6-16 West 77th Street
New York

LPC - Design Update
January 25th 2022

Comments Received - Nov 16th 2021

Main Facade Comparison

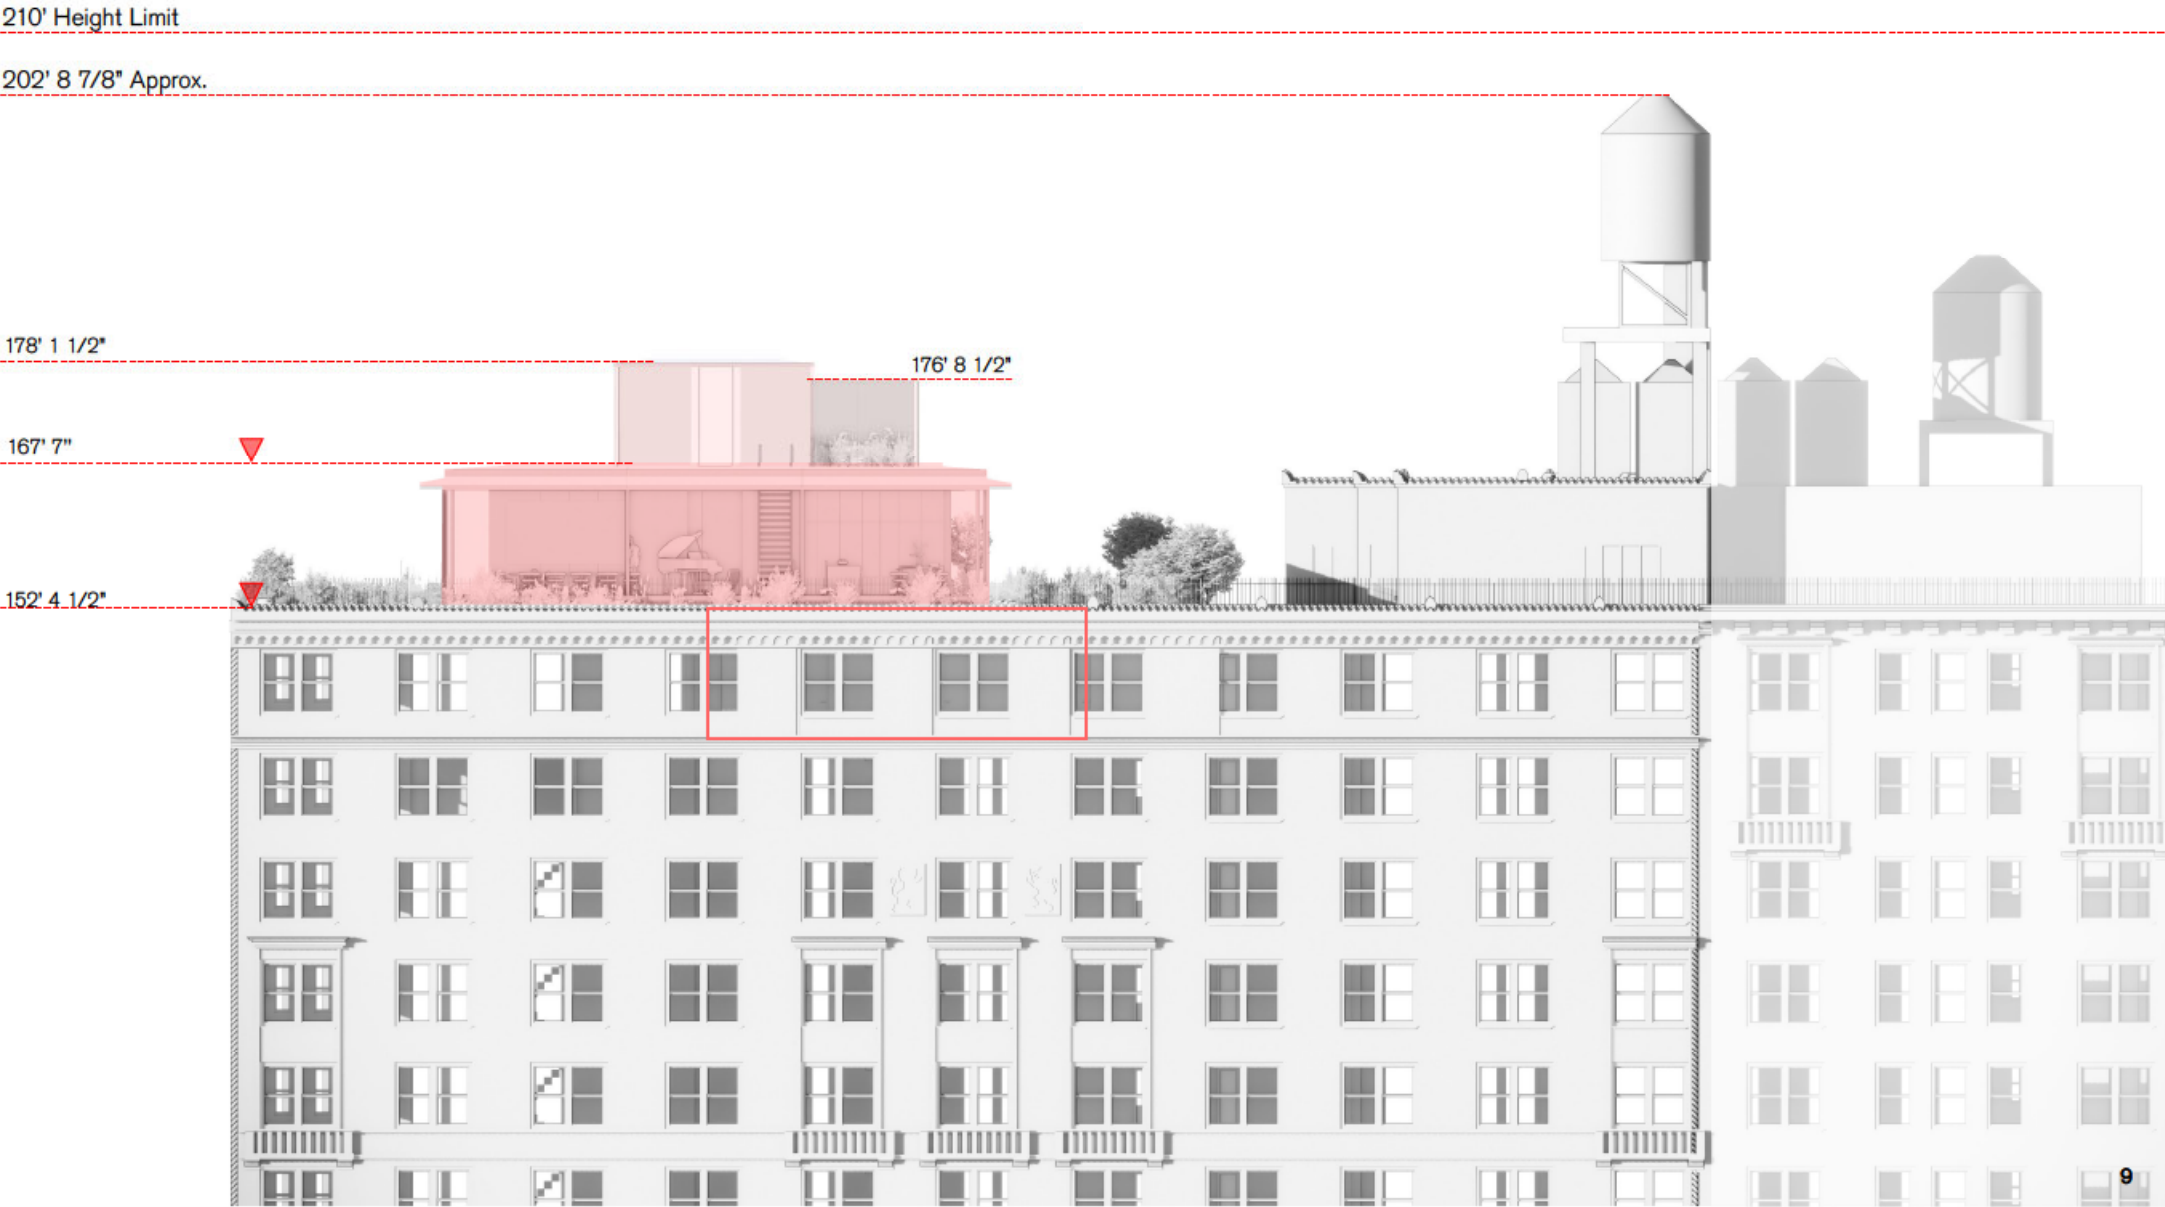
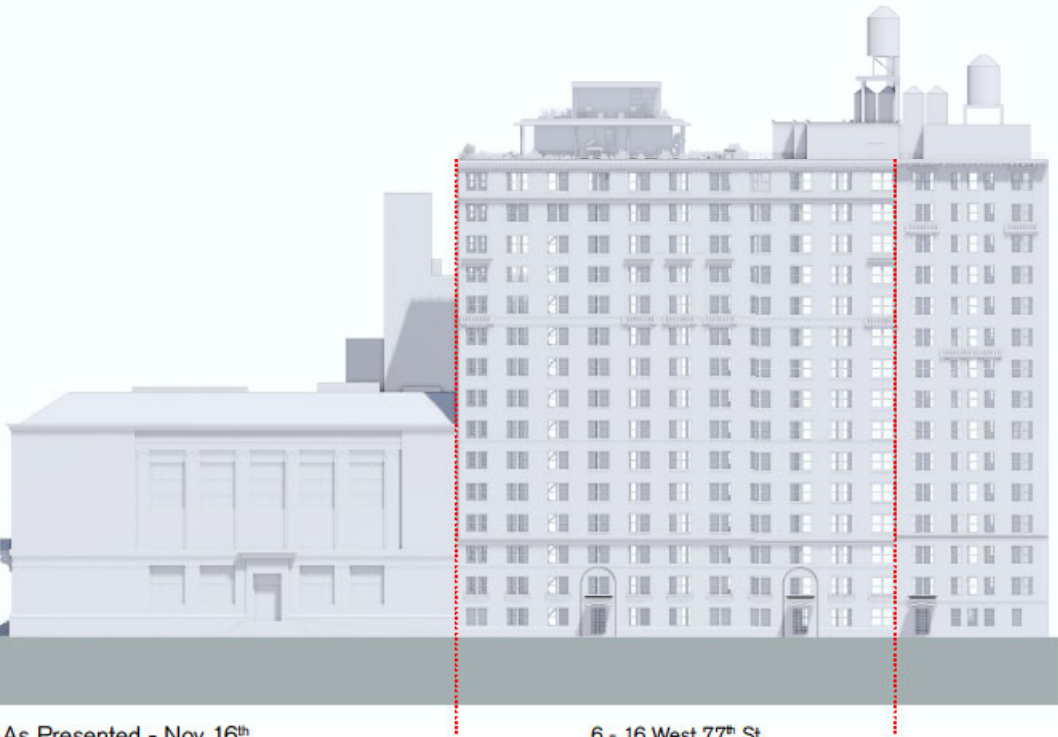
- Studio (Level 18) South face not a challenge in regards to visibility but North & Park faces could be revised
- Lower Penthouse (Level 17 + 18)
- Lower Height to reduce visibility (Level 18)
- Revised location of Level 18 (Like a Cupula) maybe move back, address elevator overrun (east)
- Video to demonstrate how visible it is

Revised Massing
